Date: **October 4, 1993**

Subject: **NEW EXTERNAL POWER JACK**

Model: **PVM-8020**

Figure 1

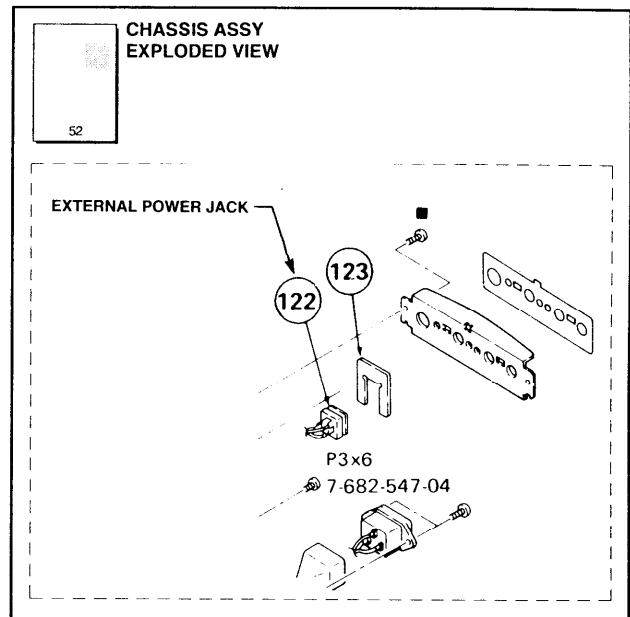
If a battery other than an BP-90 or BP90A is used, the positive side terminal of the external power jack may contact the chassis, thereby causing excessive current to flow from the battery.

To prevent this from occurring, replace the external power jack with the high-shock resistant one and add insulation tape to the bottom of the jack to isolate it from the FB block.
